## **RESPONSIVENESS SUMMARY**

**Landsburg Mine Site**  
**October 11 – December 12, 2013 Public Comment Period**

***Cleanup Consent Decree including Draft Cleanup Action Plan and SEPA  
Determination***

**Prepared by**  
Washington State Department of Ecology  
Northwest Regional Office  
Toxics Cleanup Program  
Bellevue, Washington

**Figure 4. Schematic showing how monitoring frequencies were derived using travel times at sentinel wells and compliance wells. The time difference between T2 and T1 allows for early detection and response should a release occur.**

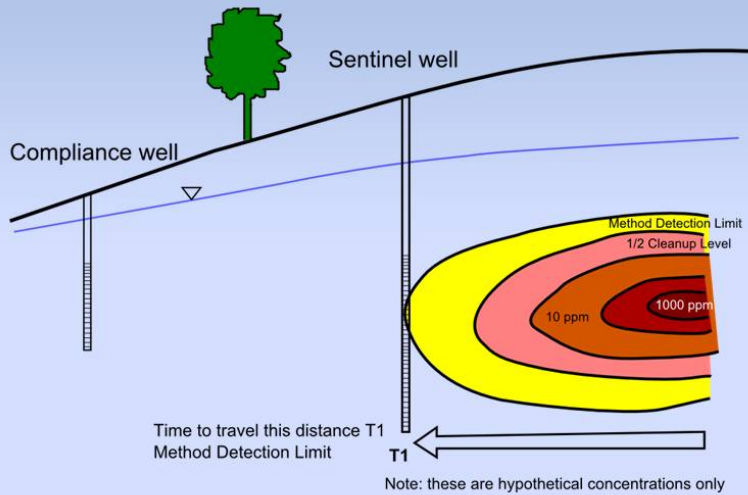
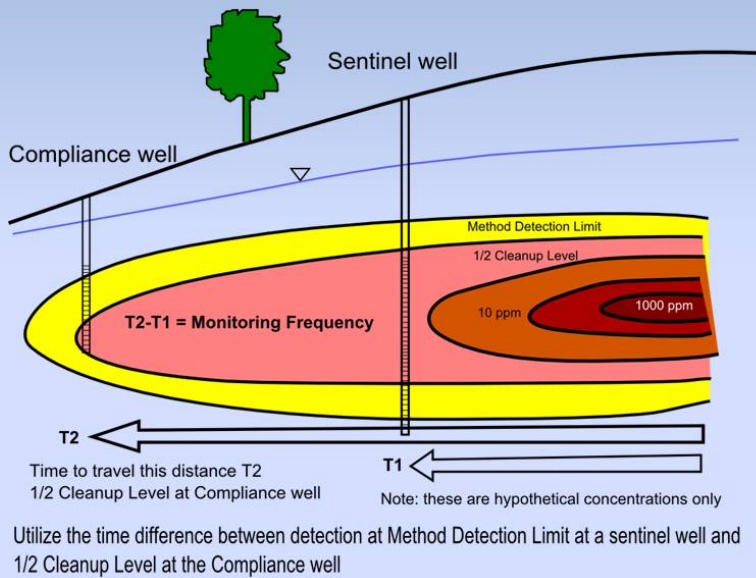
2. Jason Howell questioned the use of BIOSCREEN modeling software to determine the frequency of sampling events and suggested conducting an “empirical” study such as a dye-based study.

accurate results that allow for multiple transport simulations. The contaminant travel modeling (using BIOSCREEN) carried out in 2009 used protective (conservative) parameters that simulated worst-case scenarios for potential transport of contaminants in the groundwater. This included using the most mobile (fastest) contaminant chemicals, fast-moving groundwater speeds and rock permeabilities, no degradation (natural attenuation) of these compounds (which normally occurs during transport), and high contaminant source concentrations (which would provide a continuous source of contamination rather than a finite one as would occur in real life). The resulting monitoring frequencies are protective based on these modeling results.

In the Final CAP, sentinel wells will be part of the monitoring network. Sentinel wells are located closer to the wastes than compliance wells in order to provide early detection of any potential contaminant release. BIOSCREEN modeling results indicate that it will take years before a cleanup level is reached at the compliance wells for even the most mobile contaminants. The amount of time ranges from a minimum of three years to 142 years using ultra-conservative parameters. The modeling results provided the framework for a very protective monitoring frequency, which will ensure that potential groundwater contamination is detected before cleanup levels are exceeded at the points of compliance. This was accomplished by using the difference between the time it takes a potential contaminant to reach the sentinel well at Method Detection Limits (MDL) and the time it takes to reach the compliance well at ½ of the Cleanup Level (CUL). See Figure 4 schematic.

Using this approach, any release of contaminants at the waste area at any unknown time in the future will be detected before cleanup levels are reached at the point of compliance. This will give the PLP Group the time needed to verify results, finalize the design, and install and operate the Groundwater Extraction and Treatment System to prevent contaminant migration from the Site.
